PLANNING COMMISSION MEETING

PLANNING COMMISSION STAFF REPORT TYPE III APPLICATION

DATE OF MEETING:	July 28, 2025
FILE NO.:	25-037 DR_VAR
PROJECT NAME:	Basketball Court Shelter Variances
APPLICANT/OWNER:	Tiana Rundell/City of Sandy
ADDRESS:	18200 Meadow Drive/Deer Pointe Park
MAP/TAX LOT:	25E18CC 13400 and 25E18CD 01600
SIZE OF PROPERTY:	3.16 acres
ZONING:	Parks and Open Space (POS)
STAFF CONTACT:	Patrick Depa, Senior Planner

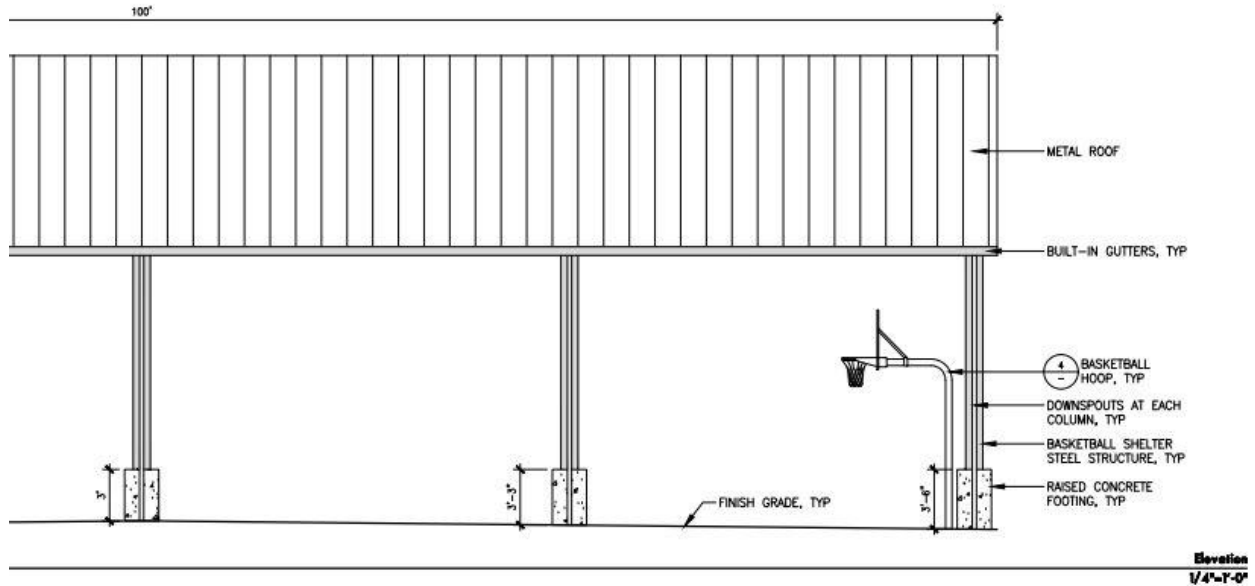
Finding 7. The only structure is a proposed picnic shelter which has no walls, so no entranceway/pedestrian shelter is required.

3. Building Materials. Exterior building materials shall convey an impression of strength and durability consistent with the Sandy Style, as follows:

(Figure 2)

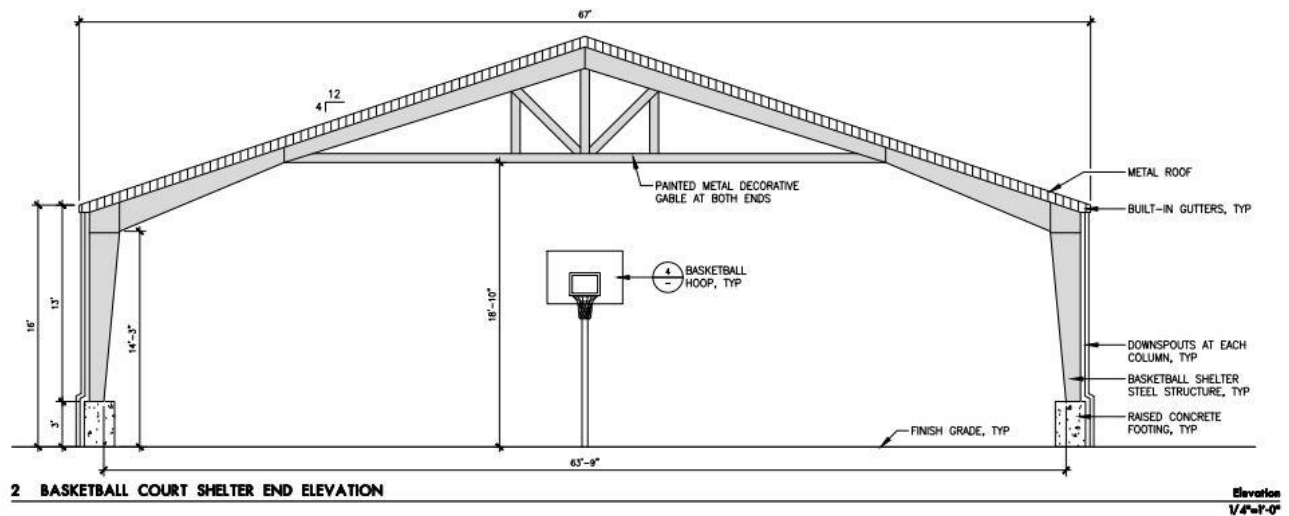
Finding 8. The basketball court shelter has a similar open-air design (no walls) as the proposed picnic shelter already approved for the park. However, where the picnic shelter has steel columns wrapped in stone that meet the above requirement to include strong base materials such as natural stone, split-faced rusticated concrete block, or brick, the basketball court shelter columns are not proposed to include such materials. The columns on the basketball court shelter are proposed to be steel but, will be set in a raised concrete base/footing (see Figure 2). **The exposed footings will be raised to show a 36-inch-high grey concrete base but without a stone wrap which will require a variance to Section 17.90.120.B.3.b. The applicant applied for a Type**

III Special Variance according to the process defined in Section 17.66.80. that will be addressed later in this document.
